PROJECT REFERENCE NO. <b>R-5021</b>	SHEET NO. <b>UC-83</b>
DESIGNED BY: <b>MEP</b>	
DRAWN BY: <b>MEP</b>	
CHECKED BY: <b>BMB</b>	
APPROVED BY: <b>BMB</b>	
REVISED:	NORTH CAROLINA DEPARTMENT OF TRANSPORTATION UTILITIES ENGINEERING SEC. PHONE: (919) 707-6690 FAX: (919) 250-4151
UTILITY CONSTRUCTION PLANS ONLY

### UTILITY CONSTRUCTION

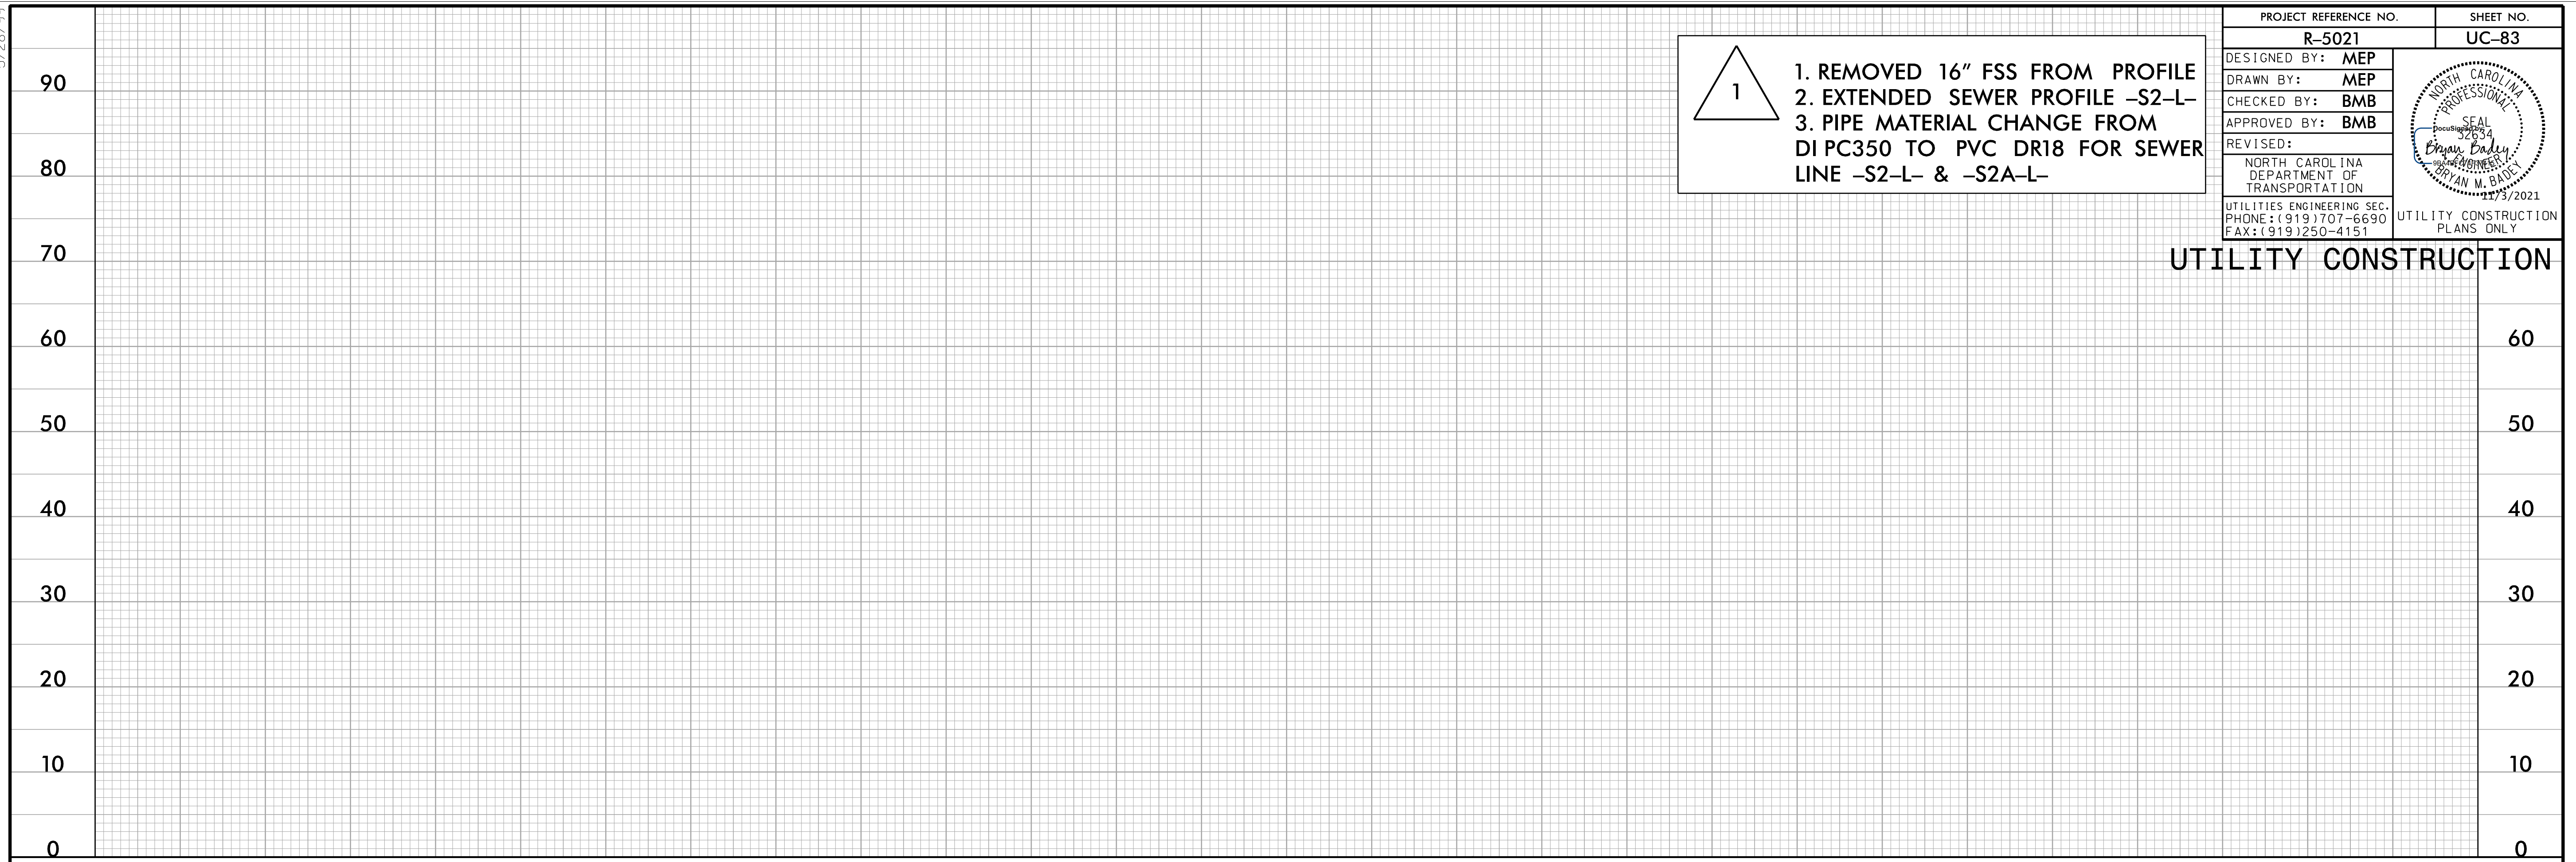
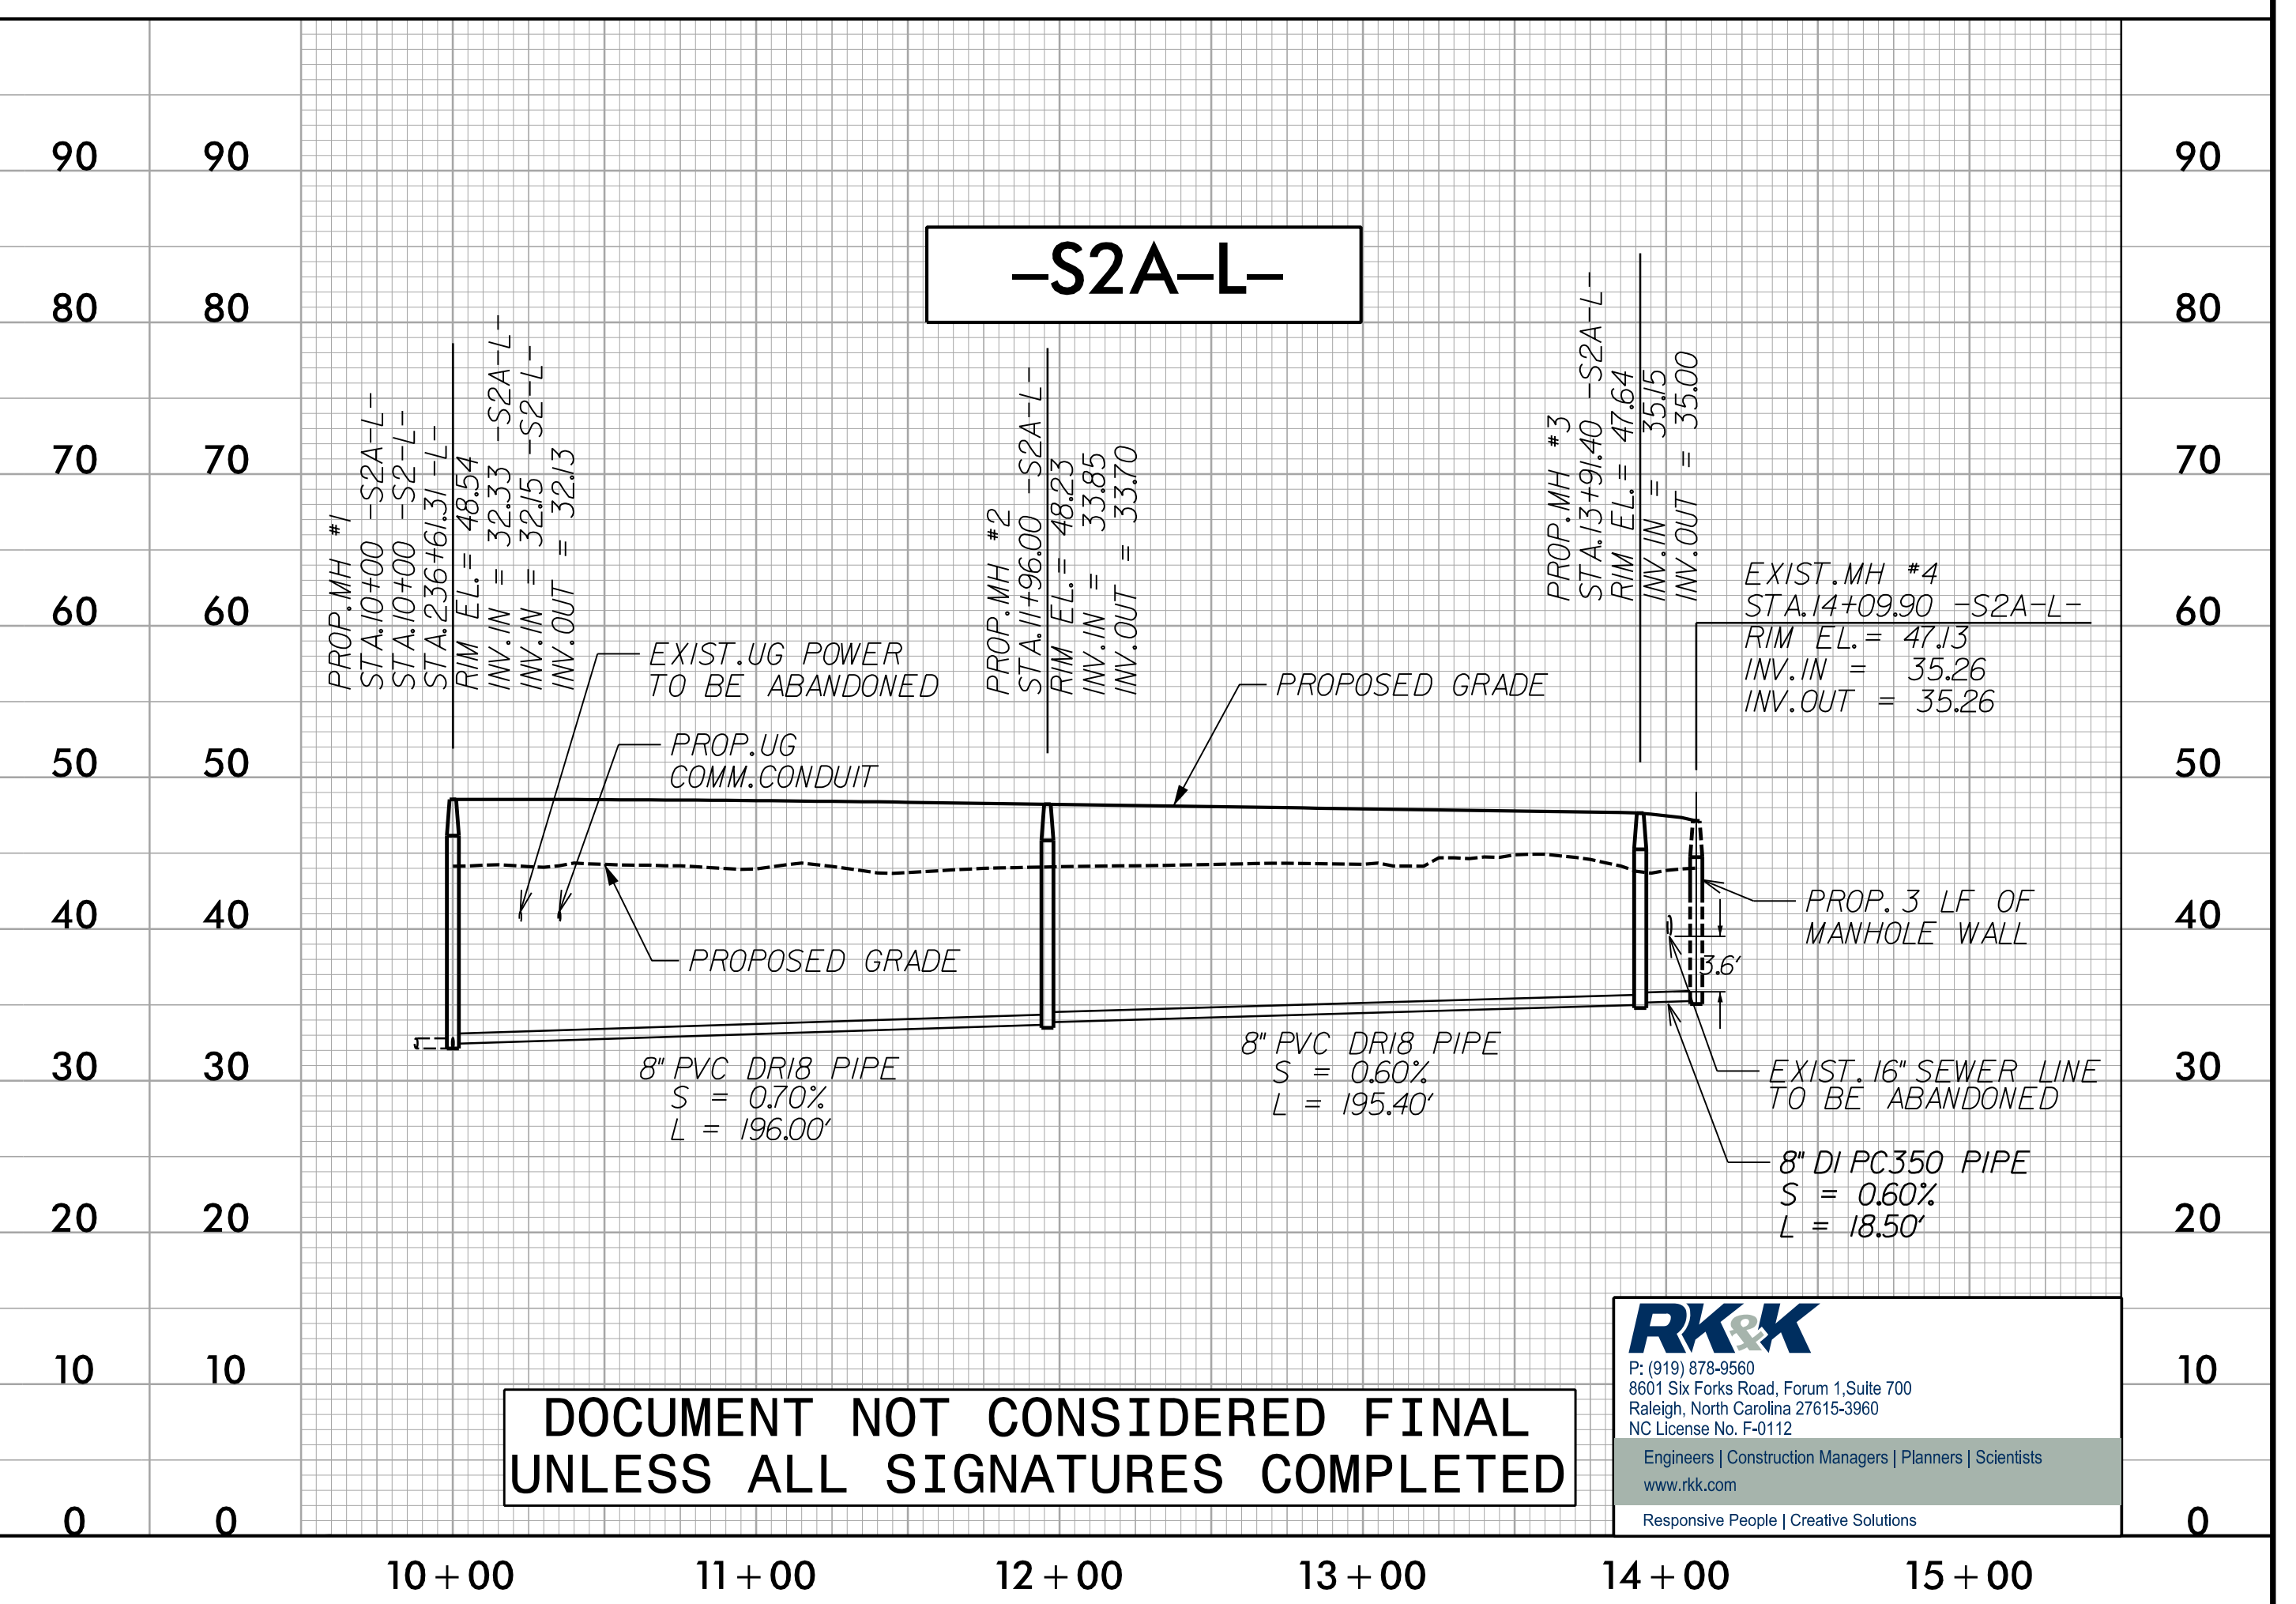
- 1. REMOVED 16" FSS FROM PROFILE
- 2. EXTENDED SEWER PROFILE -S2-L-
- 3. PIPE MATERIAL CHANGE FROM DI PC350 TO PVC DR18 FOR SEWER LINE -S2-L- & -S2A-L-
